LIGHTING

■ FOG LIGHT ASSEMBLY

04Z6BE05H

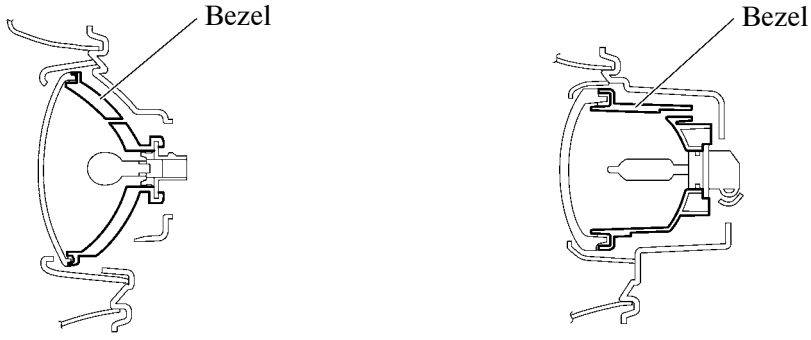
- The fog light assembly has been made larger, and the shape of the bezel has been modified.
